VC-100 - COMBO NOISE BOX SCRAMBLER

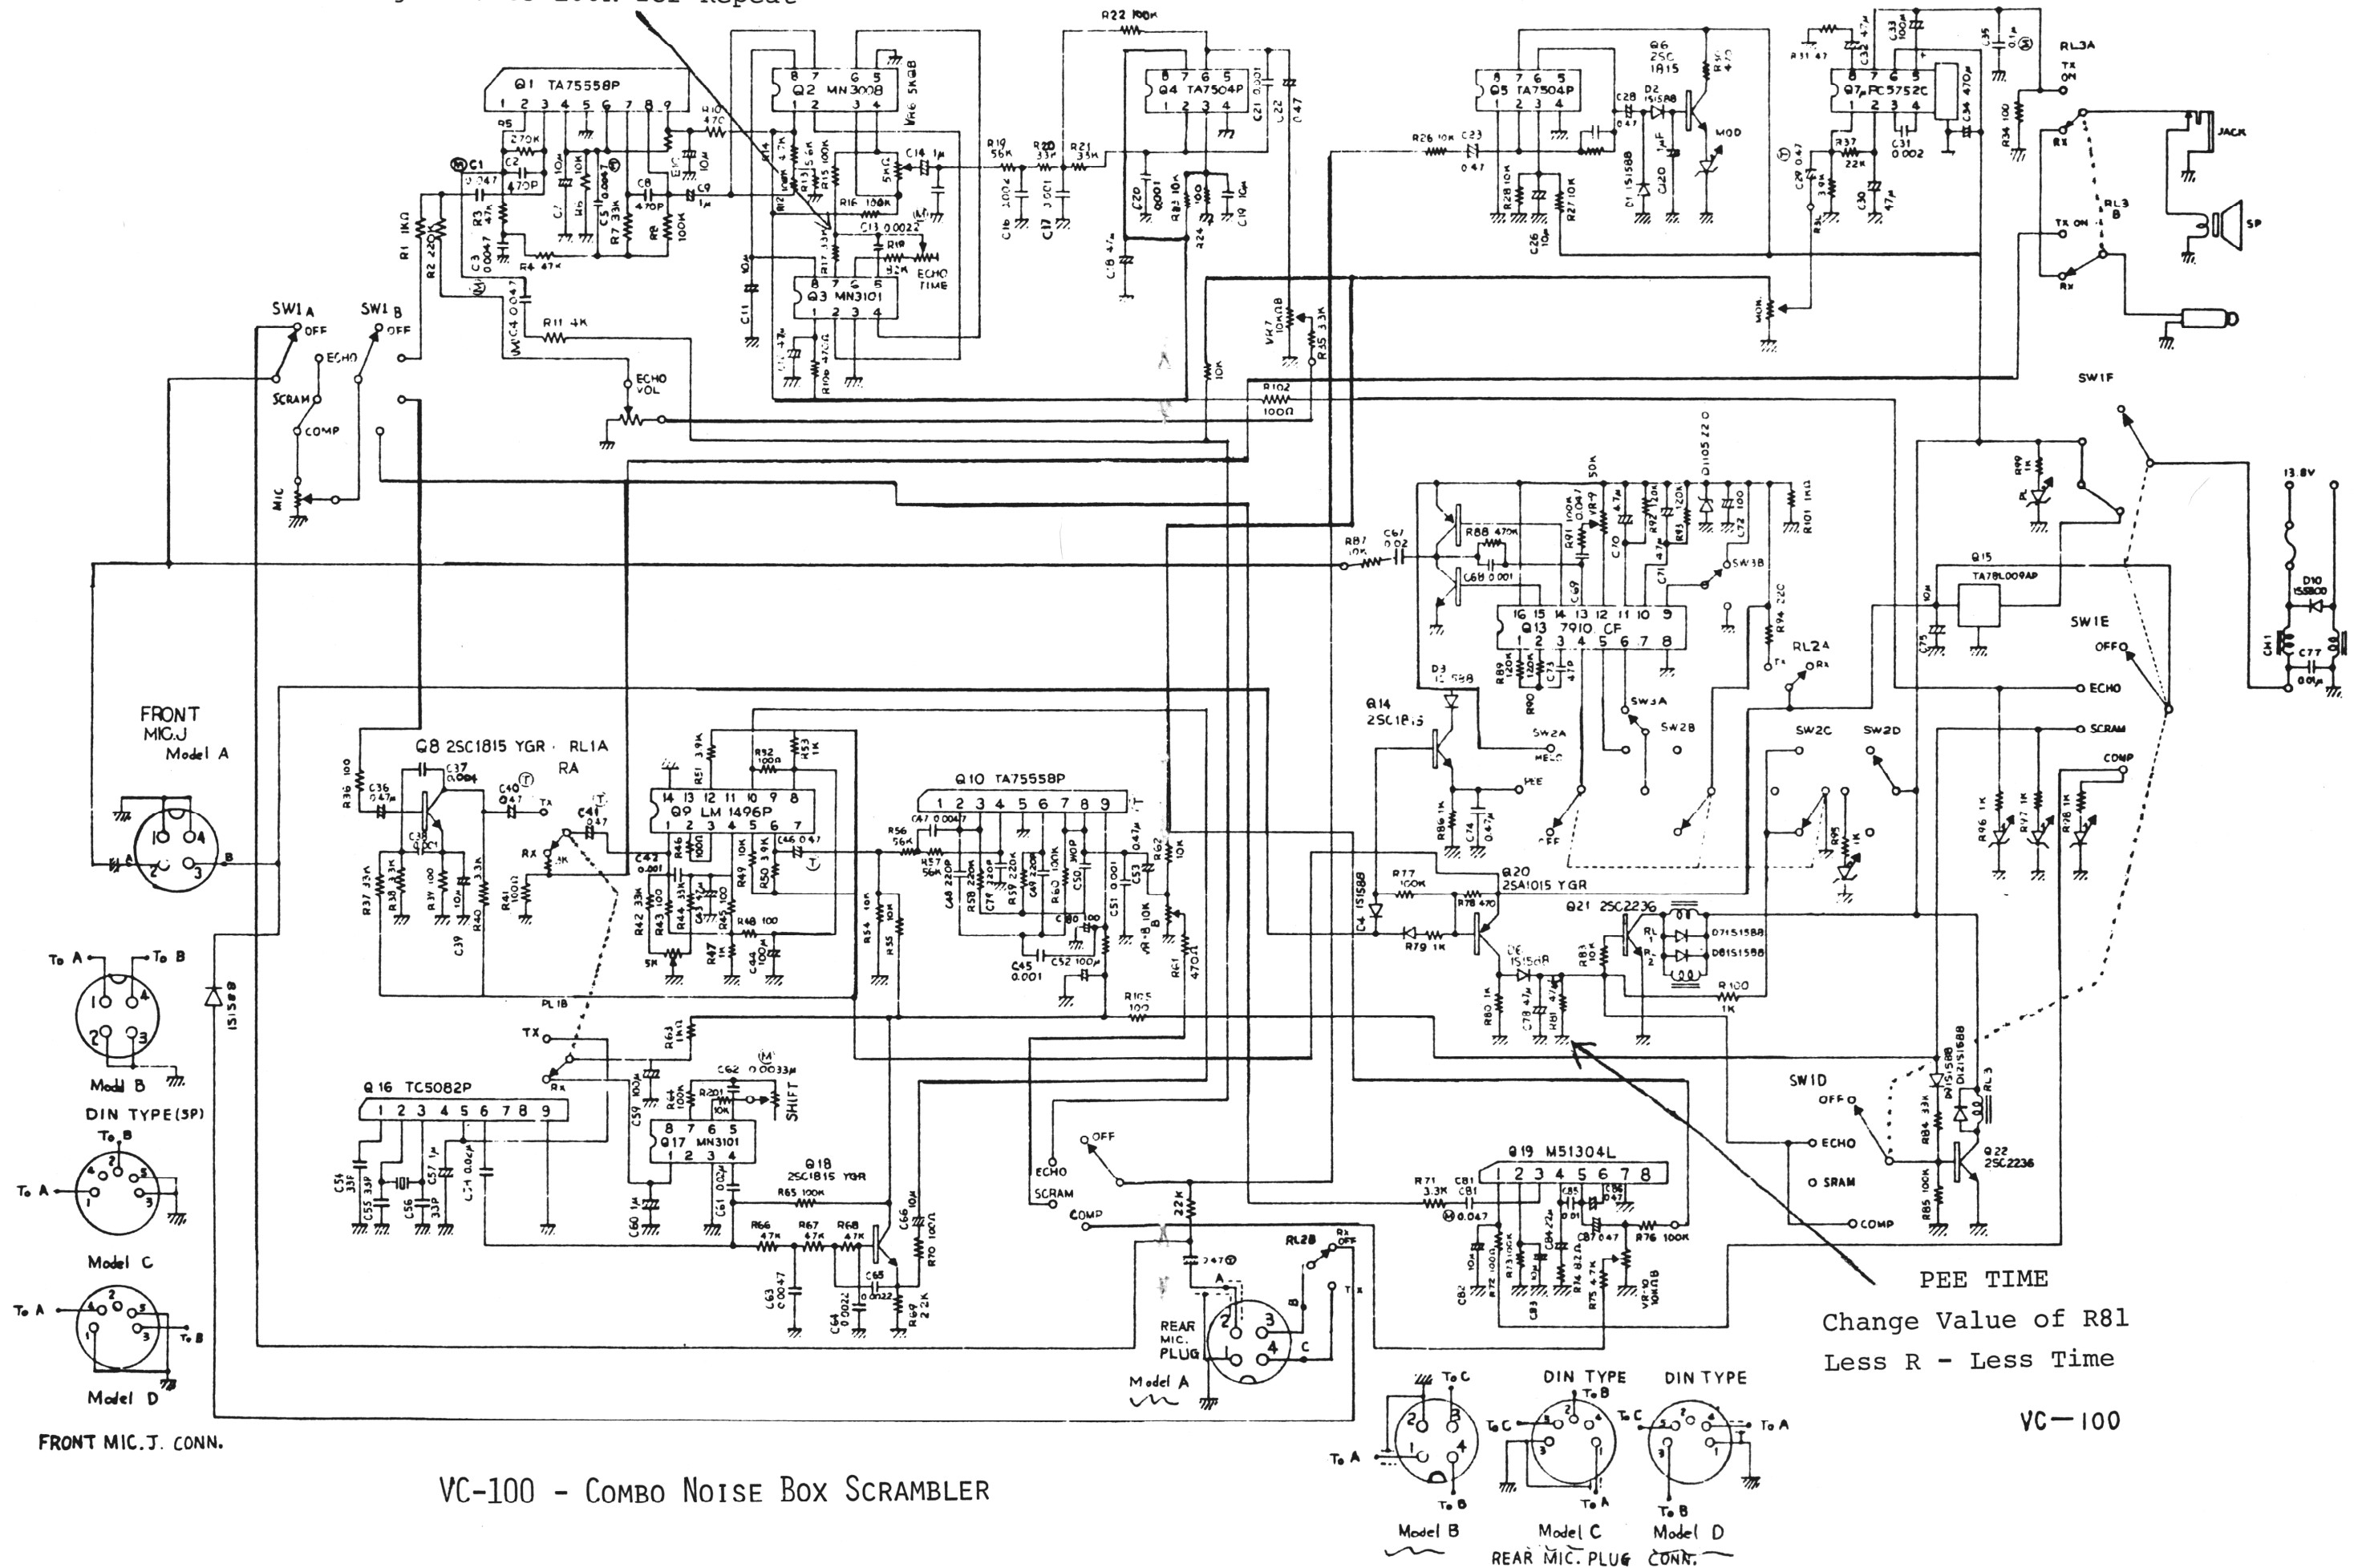
Change R17 to 100K for Repeat
